IMS Systems, Inc.
10521 Perry Highway
Suite 310
Wexford, PA. 15090
(724) 940-7160 Main Office
(724) 940-7179 Fax

6 July, 2001

Mr. Bill Ward
Mechanical Engineer
United States Nuclear Regulatory Commission
Washington, D.C.

Enclosed is our response to the letter you sent us on 28 June, 2001. We have addressed the questions in the same order that you presented them. We hope that you find the inclusions satisfactory. Please accept our apologies for some confusion over the construction parameters and the use of German in some of the drawings. We wish to make your review of our requests as smooth as possible.

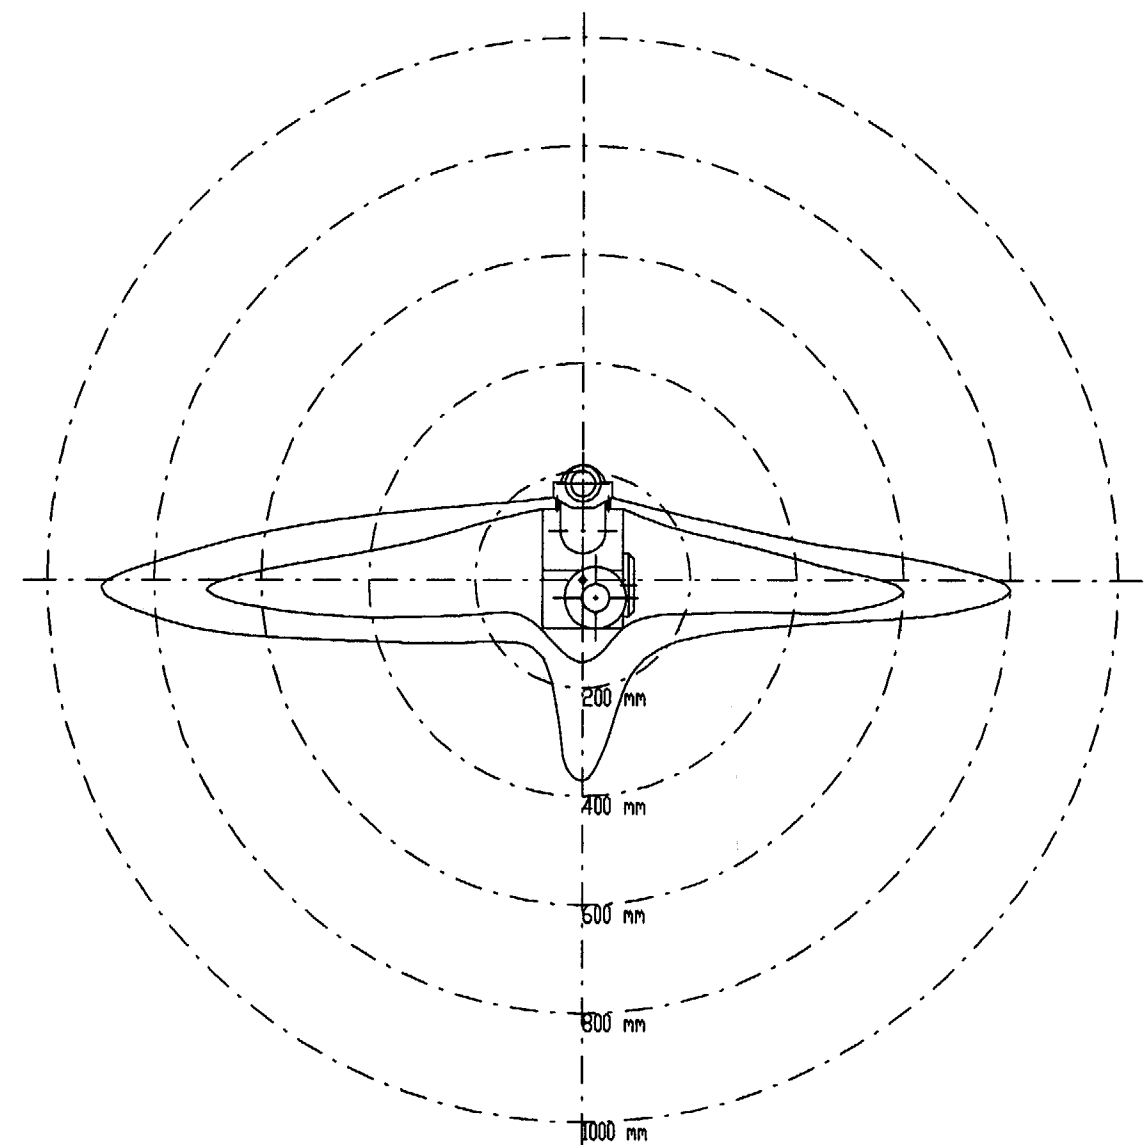
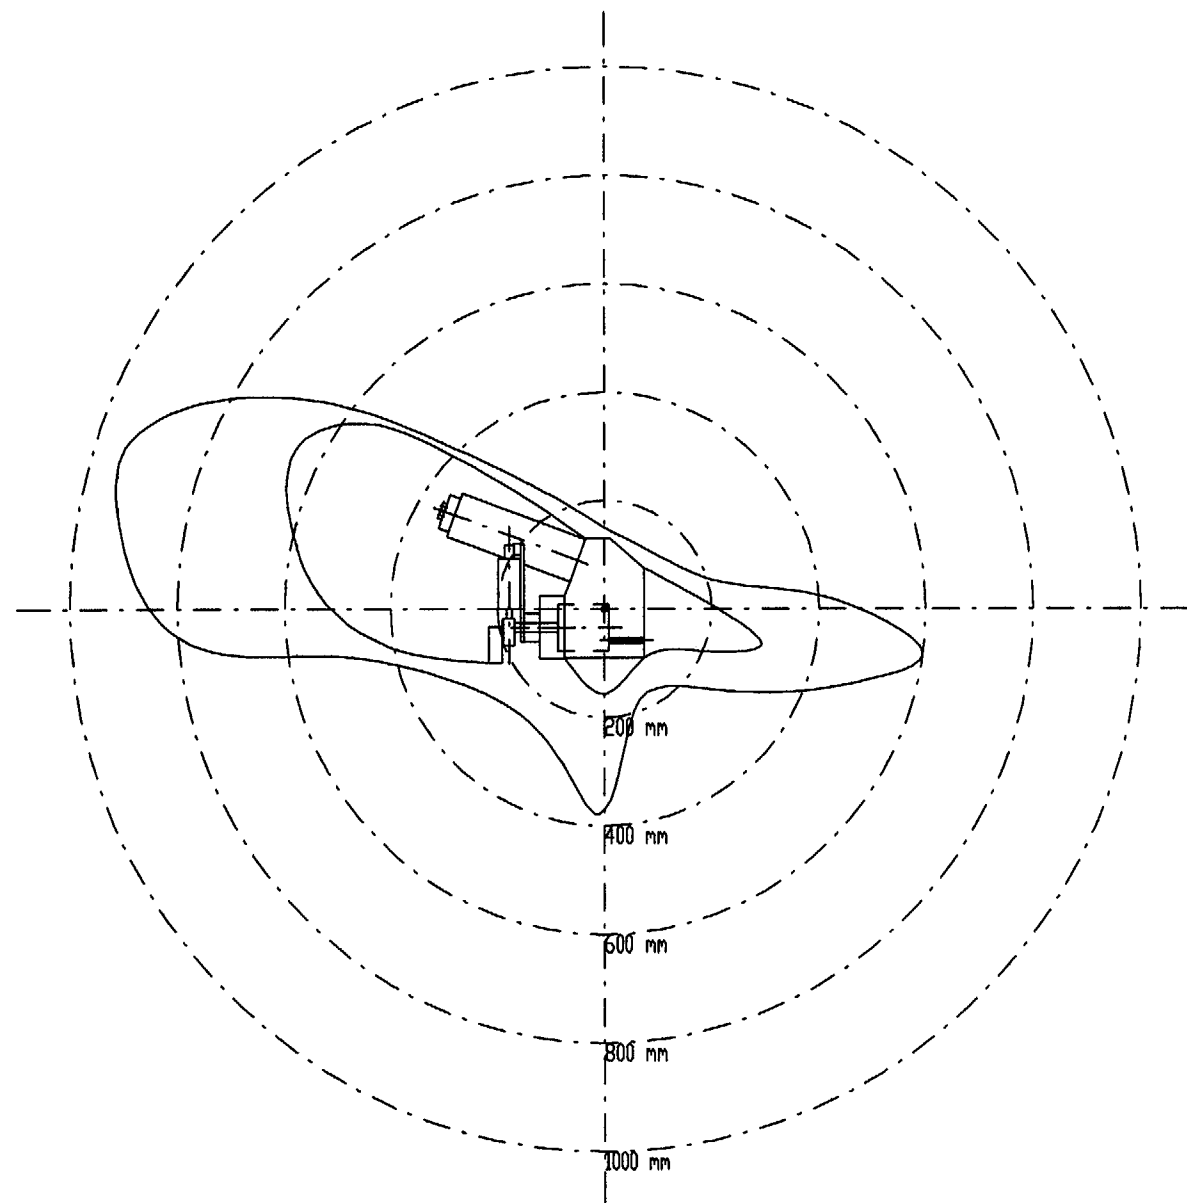
DIFFERENCE BETWEEN HOUSING DRAWING AND PICTURE: The NRC is correct (good observation). When the TIAS 212 assembly moved the detector geometry (see item 4.1), then the cylinder mounting bracket was re-designed. Due to the change, the old bolt hole pattern was difficult to access. Please see correct bracket drawing 5321-035-05

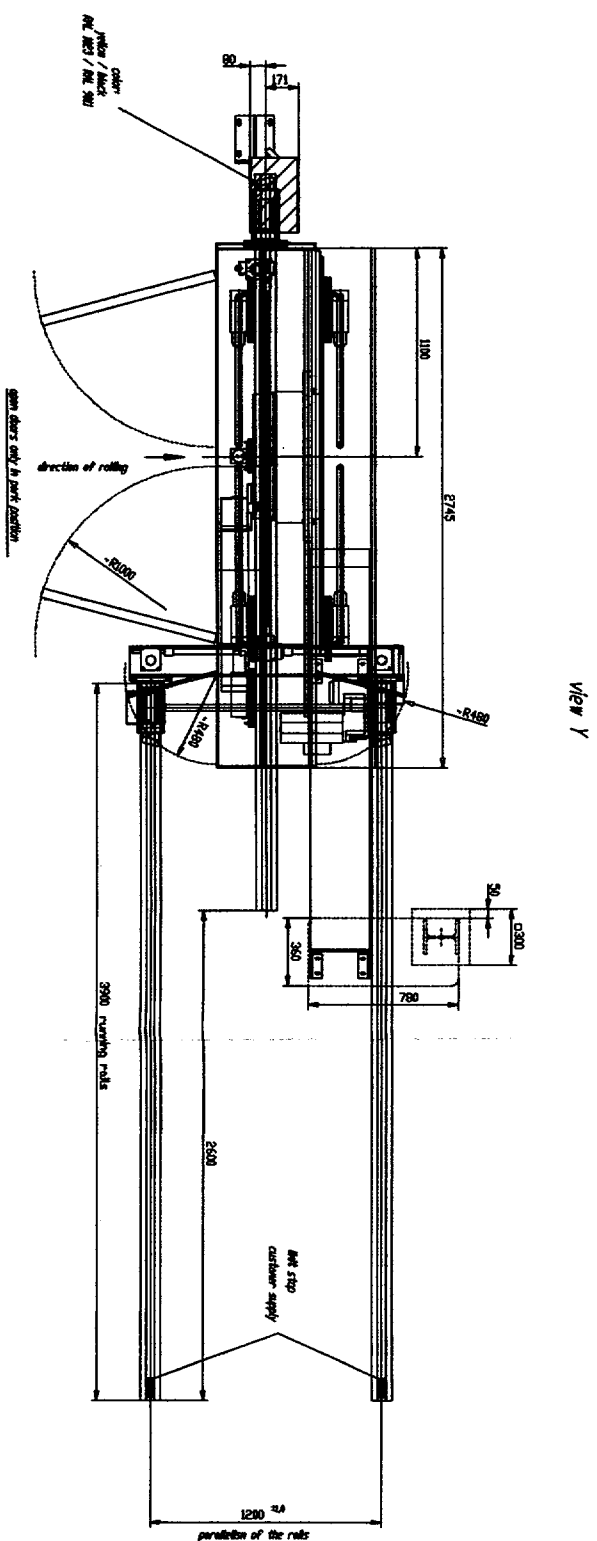
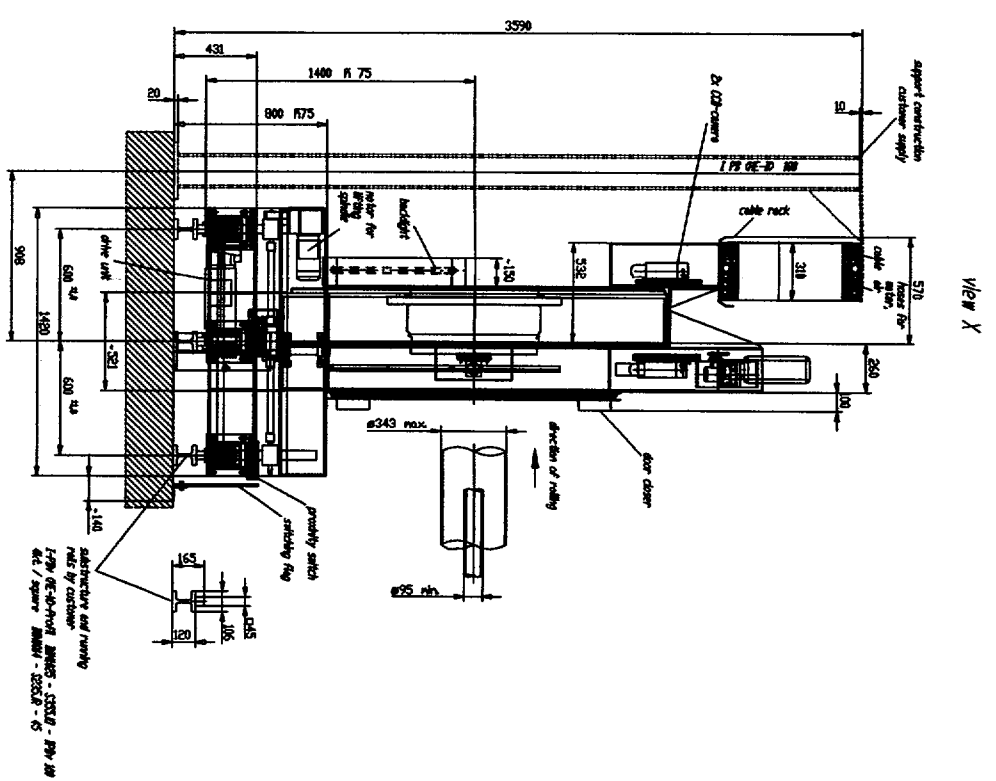
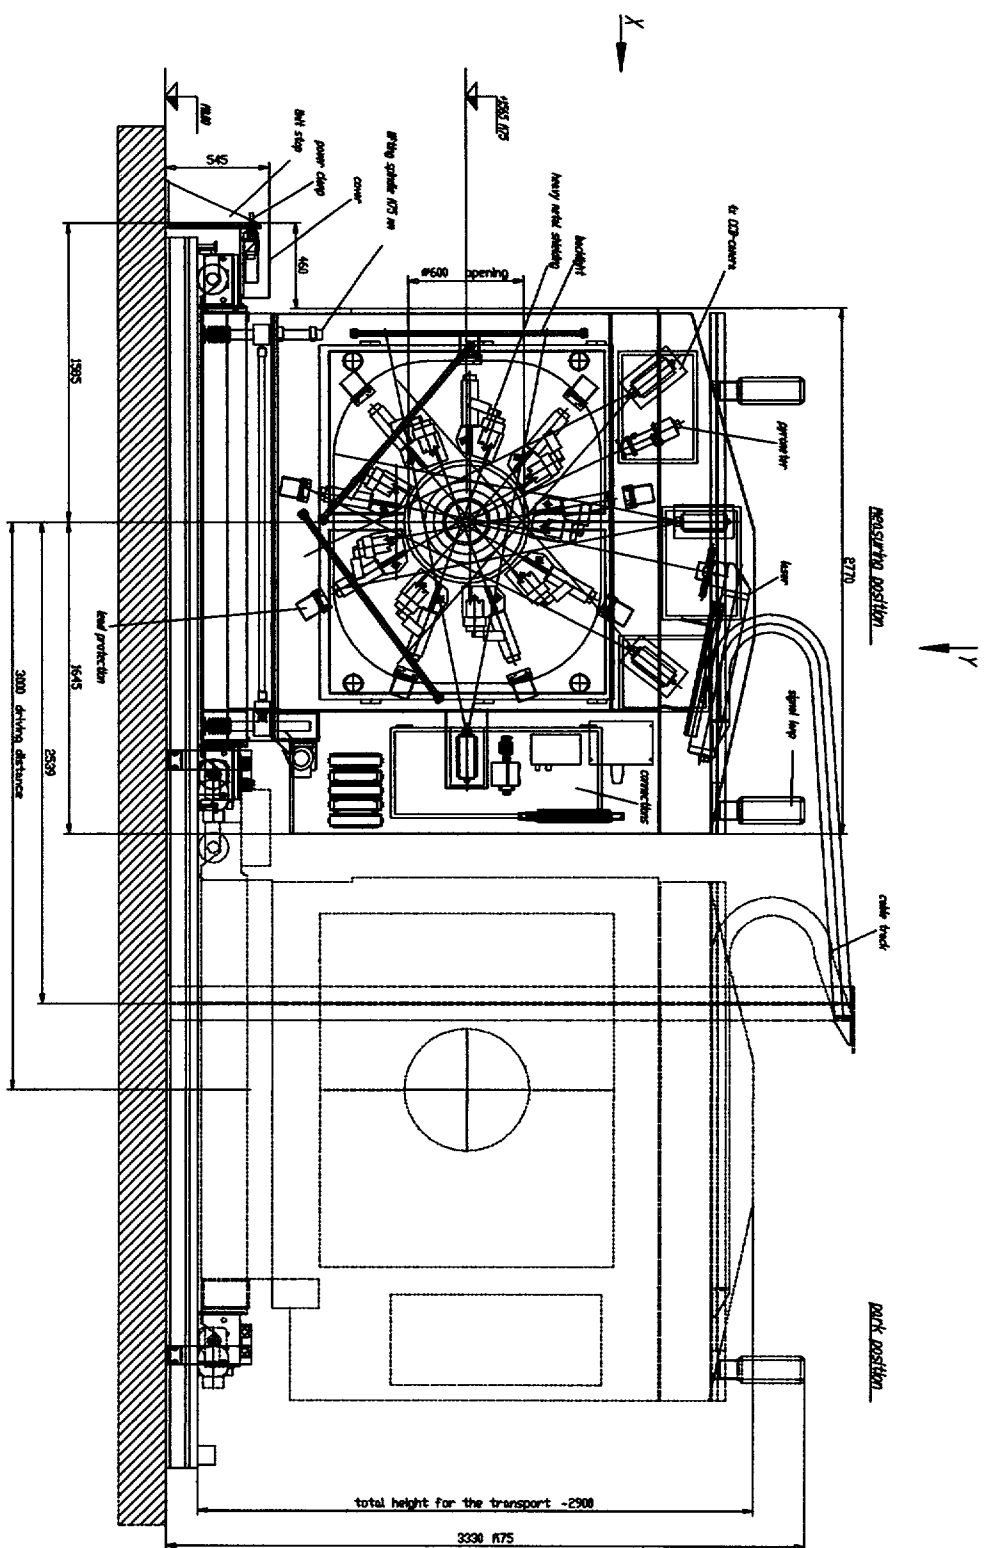
RADIATION PROFILES: Please see the attached isodose curves that are actual measurements around the gauge. As noted on page five of the ANSI testing section of the application, measurements were taken with a Babyline 31 system. The absorber information is:

300 mg/sq cm	removable cap
7 mg/sq cm	tissue equivalent (without cap)

There is no external dose when the shutter is closed. The exposure in this configuration is confined to the "O" part of the frame.
